## **VILLAGE OF DOBBS FERRY BOARD OF TRUSTEES AGENDA**

<b>MEETING DATE:</b> JUNE 8, 2021
<b>AGENDA ITEM SECTION:</b> MATTERS REQUIRING ACTION
<b>AGENDA ITEM NO. :</b> 1
<b>AGENDA ITEM:</b> REFERRAL FROM THE PLANNING BOARD FOR APPROVAL OF CONVERSION OF THREE RETAIL SPACES TO RESIDENTIAL AT 398 ASHFORD AVENUE
<b>ITEM BACKUP DOCUMENTATION:</b> <ul style="list-style-type: none"><li>1. MEMORANDUM DATED JUNE 1, 2021 FROM MS. VALERIE MONASTRA, AICP/VILLAGE'S CONSULTING PLANNER TO MAYOR ROSSILLO AND THE BOARD OF TRUSTEES</li><li>2. LETTER AND ATTACHED DRAWINGS DATED MAY 23, 2021 FROM MR. DAVID ROTBARD TO THE BOARD OF TRUSTEES</li></ul>

**SUBJECT:** 398 Ashford Avenue Planning Board Referral

**Subject** : Site Plan Review  
Owner/Applicant – Ashford Dobbs, LLC  
398 Ashford Avenue  
Tax ID: 3.100-89-1

# **SITE PLAN & ZONING ANALYSIS**

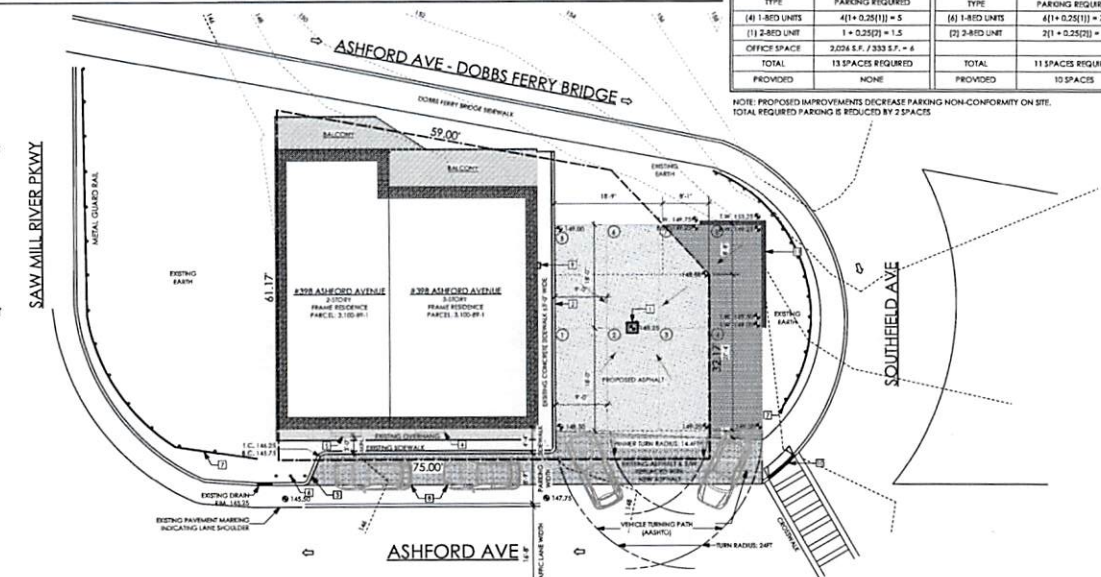
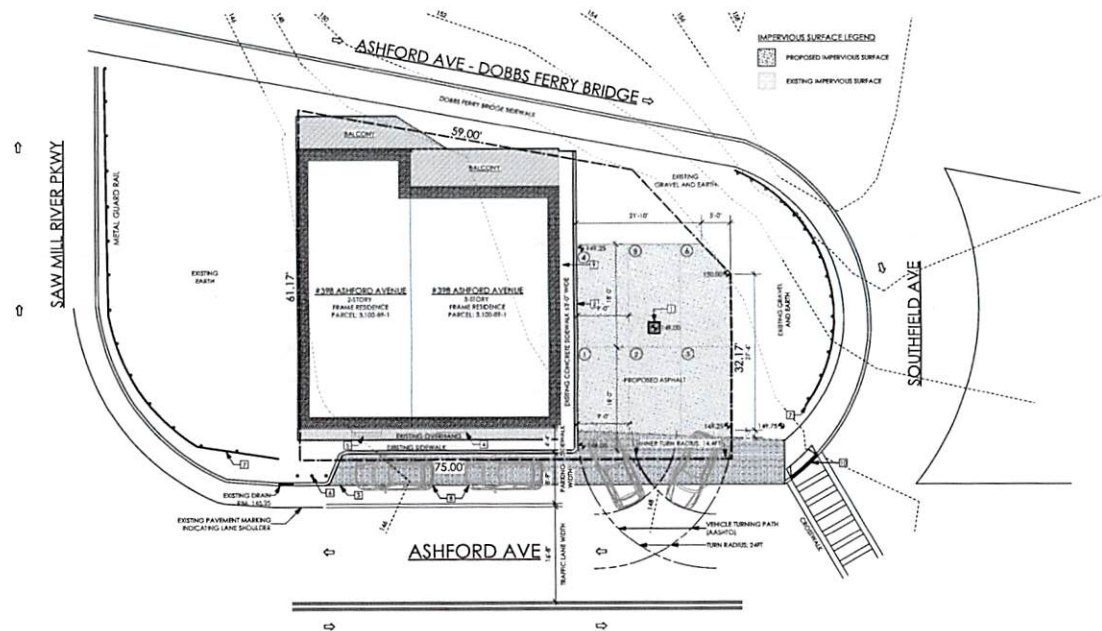
1. As noted on the plans, the proposed site improvements exceed the allowable lot coverage; therefore, a variance may be required.

2. Off-street parking and a retaining wall are proposed the adjacent lot labeled "P.O. Lot 14" which may be Village right-of-way. Per the requirements of §300-48 "Parking" C. (6) of the Village Code, off-street parking shall not be located in the right-of-way. The applicant is pursuing an easement from the owner of the lot labeled "P.O. Lot 14" which may be the Village. An easement would ease the burden of parking on side streets. This item also relates to the deficiency of parking and the number of spaces required for a "PILOP".

3. There is an existing onsite parking lot. The proposed parking design will increase onsite parking and backing out onto Ashford Avenue and into the crosswalk which may pose a safety hazard to pedestrians along the sidewalk and motorists on Ashford Avenue. Furthermore, with the proposed tandem parking may cause queuing on Ashford Avenue. The existing on-street parking stalls are proposed to be modified to improve safety and include new line striping. Due to the proximity of the parkway, any proposed improvements should be reviewed by the Village's Traffic Consultant.

4. A separate plan should be provided showing a retaining wall on the property line and no parking on the adjacent property.
5. While the building may be all residential, accessible parking spaces conforming to ADA requirements should be considered and conform to code as required.

10. A gravel parking area is proposed; per the requirements of §300-48 "Parking" C. (1) of the Village Code, gravel is not permitted for parking areas in the DT zone.

2 24'x24' CATCH BASIN DETAIL  
Scale: 3/4" = 1'-0"

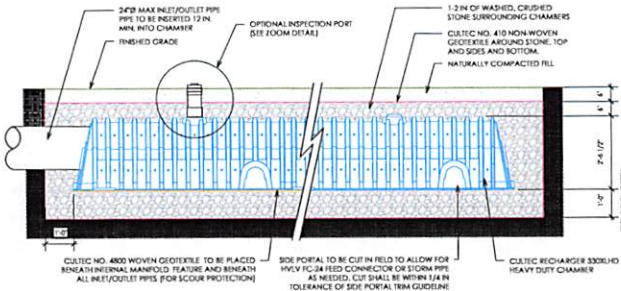
12. The catch basin should include a 24" sump for pretreatment and the pipe should have 24" minimum of cover. The detail and elevations should be revised. Additionally, it should be confirmed the catch basin can withstand H-20 loading.

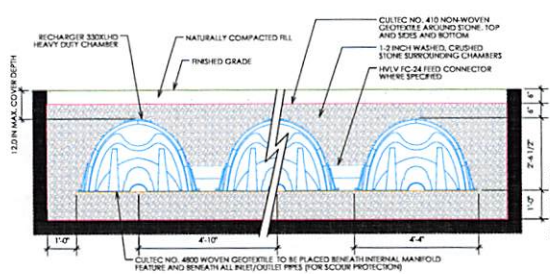
11. As previously mentioned, the proposed stormwater mitigation system should be sized for the increase in stormwater runoff due to the 100-year storm event. The site appears to pose setback limitations which may allow for a lesser storm event. Stormwater discharge ultimately flows into the Saw Mill River which is a NYSDEC impaired water body. An overflow is recommended to the existing catch basin.

13. As previously mentioned, soil testing in accordance with Appendix D of the NYSDEC Stormwater Management Design Manual should be performed to confirm separation and infiltration requirements. The proposed stormwater system relies on infiltration to mitigate the increase in runoff. As a result, soil testing is important to verify the assumptions made.

**SURVEY OF PART OF  
LOT Nos. 11, 12 & 13  
AS SHOWN ON MAP OF PROPERTY AT  
ASHFORD  
LATELY BELONGING TO MEYER H. MEYER  
AND NOW PARTLY LAID OUT IN BUILDING  
LOTS FOR E.G. CUNNINGHAM  
LOCATED IN THE  
VILLAGE OF DOBBS FERRY  
TOWN OF GREENBURGH  
WESTCHESTER COUNTY, NEW YORK.**

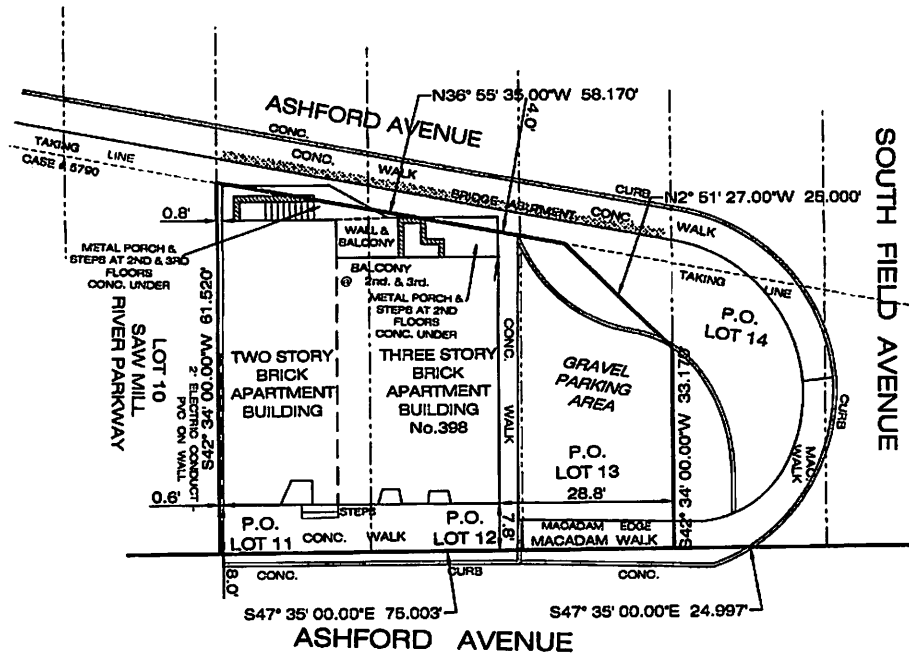
6. The proposed pedestrian ramp in the right-of-way should conform to ADA and Village standards.
7. The site plan should reference the survey by Gabriel E. Senior, P.C. that was provided with the submission documents.

8. The survey and site plan should be revised to include the existing utility pole located in the right-of-way on "P.O. Lot 14".
9. Walkway, pedestrian ramp and retaining wall details should be provided. Additionally, the curb detail should show the full curb height.
